Re: Huntlee Residential Subdivision – Stage 1 Modification 14 (MP 10_0137 MOD14) - Detention Modelling

Northrop Consulting Engineers have prepared the following letter in response to the comment 7 made by Planning Industry and Environment's Biodiversity and Conservation Division (BCD) dated 13 January 2021 in review of the Huntlee Residential Subdivision Stage 1 Modification 14 Application (MP 10_0137 MOD 14).

Figure 1 – Overlay of development footprint within the wider Black Creek Catchment.

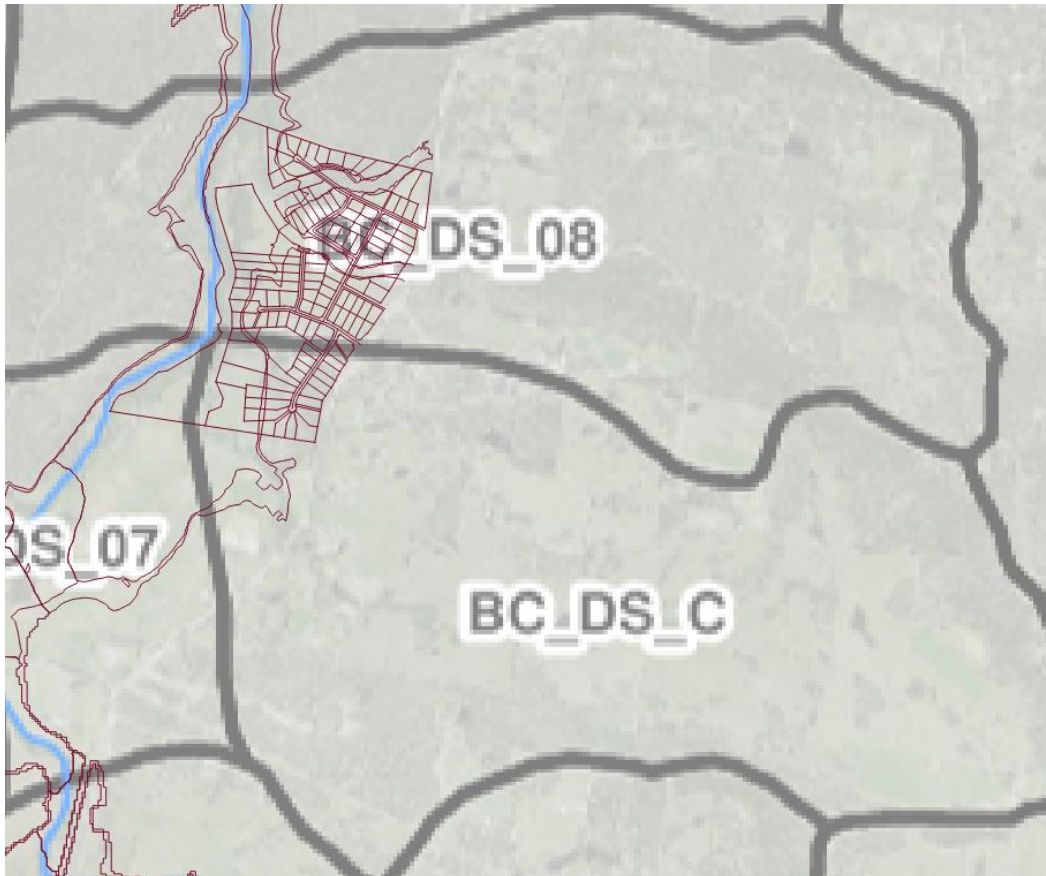
7. The proponent should revise flood modelling using the broader Black Creek flood model to determine if on-site detention can be removed from the proposal without causing additional flood impacts.

- An assessment of the impervious area has been undertaken. The total development area ~44.3 ha at 45% impervious results in a total impervious area of ~20ha. 86% of these falls within BC_DS_08 and 14% within BC_DC_C. The location of the development with respect to the catchments is presented below in Figure 1.
- The WBNM file for the 1%AEP, 36 hours has been amended to account for an increase in impervious fraction. BC_DS_08 impervious fraction increased from 0.00% to 3.46% and BC_DS_C impervious fraction increased from 0.00% to 0.58%.
- The WBNM was rerun to generate hydrograph inputs for the TUFLOW model.
- The TUFLOW model was rerun for the 1%AEP 36 hour.
- A comparison of the elevation rasters was undertaken.
